HOLODOMOR MEMORIAL DESIGN COMPETITION

QUESTIONS & ANSWERS

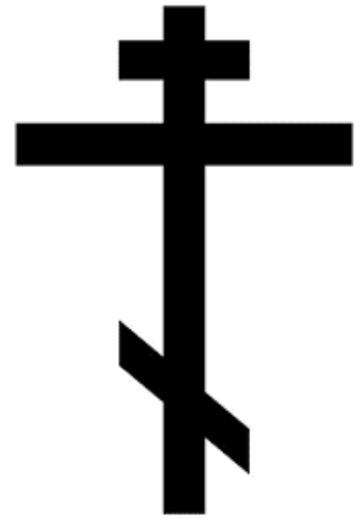
Q4. What do you mean when discussing the lines? Do you mean lines cut into the metal? Please clarify.

A4. The “lines” are the smallest amount of material that is left in between any open areas of a design.
